Access Compliance Report

Public Rights-of-Way

(Curb Ramps)

Intersection ID: 5654	Main Street: JOHN_KIRK_DR	Cross Street: VAN_LANDINGHAM_RD	Location: NW
ADA ID: E6977175D80F	Ramp Type: Perp	Initial Pass/Fail: Fail	Overall Compliance: No
Severity Score: 1.25			
Codes/Mitigation Info/Possible Solution		Field Measurements/Component Compliance

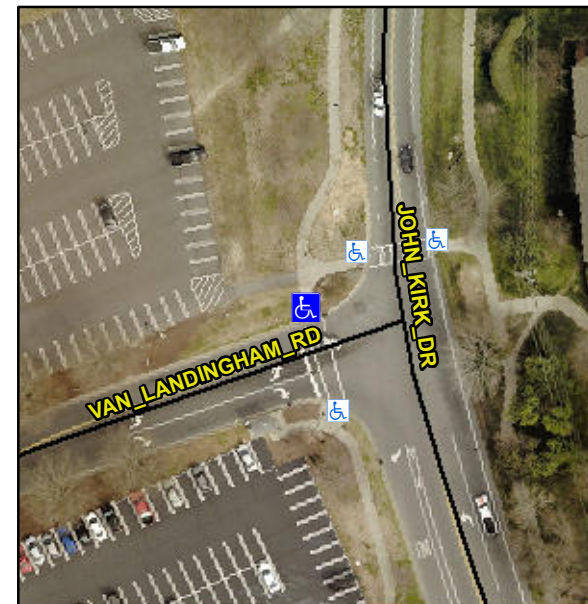
Not Found, R304.5.3

Compliance	Description	Data	Compliance	Description	Data
N/A	Ramp Length (in)	76.0	Yes	Ramp Slope (%)	6.4
Yes	Ramp Width (in)	69.0	No	Ramp XSlope (%)	2.8
N/A	Flare Type LT	N/A	N/A	Flare Type RT	N/A
N/A	Flare Slope LT (%)	N/A	N/A	Flare Slope RT (%)	N/A
N/A	Flare Traversable LT?	N/A	N/A	Flare Traversable RT?	N/A
N/A	Landing Length (in)	N/A	N/A	DWS Provided?	N/A
N/A	Landing Width (in)	N/A	N/A	DWS Contrast?	N/A
N/A	Landing Slope (%)	N/A	N/A	DWS Length (in)	N/A
N/A	Landing X Slope (%)	N/A	N/A	DWS Full Width?	N/A
N/A	Landing Curb? (Y/N)	N/A	N/A	DWS Offset (in)	N/A
N/A	Shared Landing?	N/A			
N/A	Gutter Ponding?	N/A	N/A	Gutter Slope (%)	N/A
N/A	Gutter Lip Ht (in)	N/A	N/A	Gutter X Slope (%)	N/A
N/A	Painted X Walk1?	Yes	N/A	Painted X Walk2?	N/A
	X Walk 1 Direction	To S		X Walk 2 Direction	N/A
N/A	X Walk 1 Width (in)	112.0	N/A	X Walk 2 Width (in)	N/A
	X Walk 1 Slope (%)	0.4		X Walk 2 Slope (%)	N/A
	X Walk 1 X Slope (%)	3.5		X Walk 2 X Slope (%)	N/A

Remove & Replace Entire Ramp.
